**TB KLN018**

## **TECHNICAL BULLETIN**

**For the Attention of :** SLL Testers, Service Engineers, Training Dept.  
**From:** Tony Knapp – Product Support Engineer  
**Date:** 08 April 2019  
**Product:** Kleemann  
**Subject :** **LiSA 20 Controller Error 75**  
**Pages :** 1 of 4

| <b>Bulletin Title: Error 75 on LISA20 controller (EN81.20)</b>  |  |   |  |

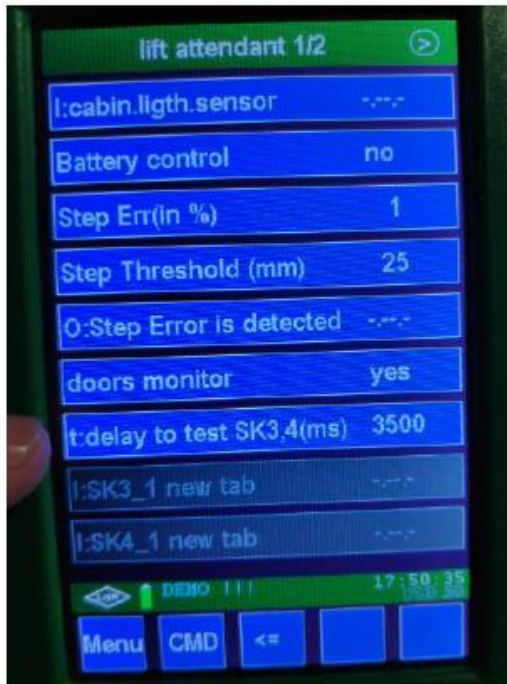
| <p>This bulletin has to do with the error 75 that appears in LISA20 that could be down to timing value of the door check. Of course if the value is already by the factory at the desired level of 3500, then you should try to address the fault in different aspects following the bellow capture of fault explanation from LISA20 manual.</p> <p>To check and alter this value type in command menu 7028 and OK (please see capture bellow) and then change the value of &lt;t:delay to test SK3/4 (ms)&gt; to the value of 3500<br/>Please remember to Save the change when you exit to main page.</p> <p>You should expect all recent projects dispatched after May 2018 to have this parameter update by the factory.</p> |  |   |  |

Error 75 is the timing of the door check.  
If the value of the door check is below 3500 the error could occur putting lift out of service. The default setting from the factory has been as low as 1500. This should be increased to a minimum of 3500 to prevent error 75.

If Error 75 is logged, check parameter setting as per bulletin
